UNITED STATES PATENT AND TRADEMARK OFFICE

APPLICATION NO.	FILING DATE	FIRST NAMED INVENTOR	ATTORNEY DOCKET NO.	CONFIRMATION NO.
10/680,490	10/08/2003	Pieter Vorenkamp	1875.3610001	5497

Office Action Summary	Application No. 10/680,490	Applicant(s) VORENKAMP ET AL.	
	Examiner Betsy L. Deppe	Art Unit 2611

DETAILED ACTION

FIG.1

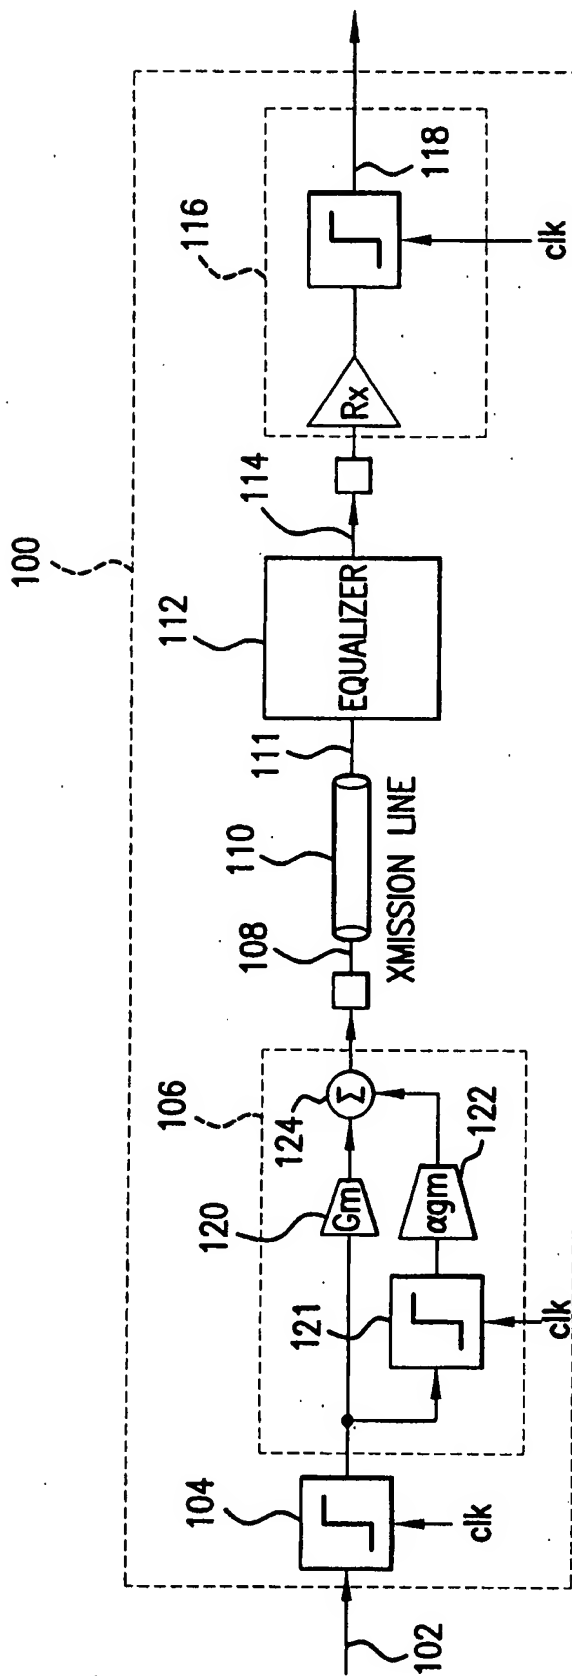
Acceptable.
B Depne
 9/6/07
